Product Change Notification

110135 - 00

Change Notification #:	110135 - 00
Change Title:	Intel Ethernet SFP+ SR Optic kit, E10GSFPSR MM#903239 and Intel Ethernet SFP+ LR Optic kit, E10GSFPLR MM#903240 (Spring Fountain SR/LR optic kits) PCN 110135-00 Transport Media, Product Material, Product Marking and Label Box, Clamshell, Label Changes, Adding an Additional Optic Supplier
Date of Publication:	July 23, 2010
Key Characteristics of the Change:	
Transport Media	
Product Material	
Product Marking	
Label	
Forecasted Key Milestones:	
Date Customer Must be Ready to Receive Post-Conversion Material:	August 23rd, 2010

Adding an Additional Optic Supplier:

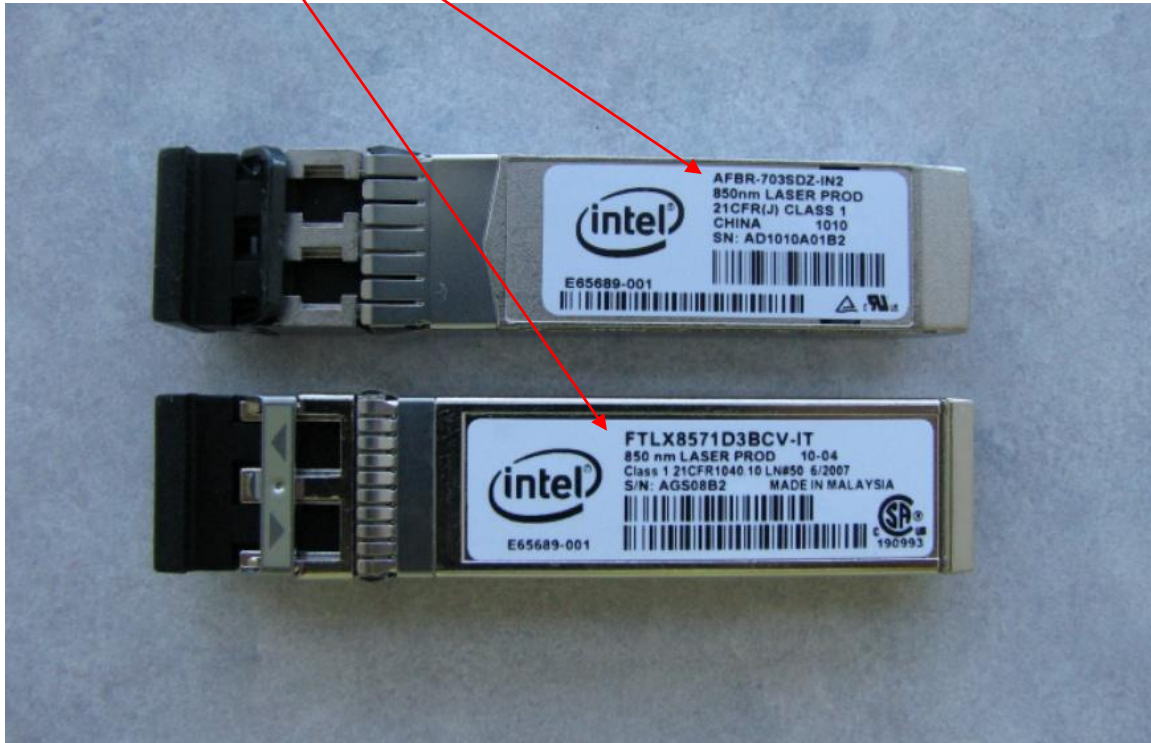
As an ongoing part of Intel's manufacturing and operations processes, multiple suppliers are sought for certain commodities. Currently Intel uses multiple optic module vendors in our fiber Network Interface Cards (NICs).

Intel has added a second source supplier to supply the optic modules for use in the Optic kits noted within this PCN notification. Intel already uses this second source supplier on our Intel® Ethernet Server Adapter X520 product family line, which has been shipping since August of 2009. As in all parts and commodities that are multi-vendor sourced, specifications and functionality are equivalent to currently used ones, and both optic suppliers have been fully qualified by Intel.

Customers can now expect to receive Optic kits with either one of the following manufacturing part numbers.

Customers might expect to receive mixed inventory from either supplier when ordering Optic kits.
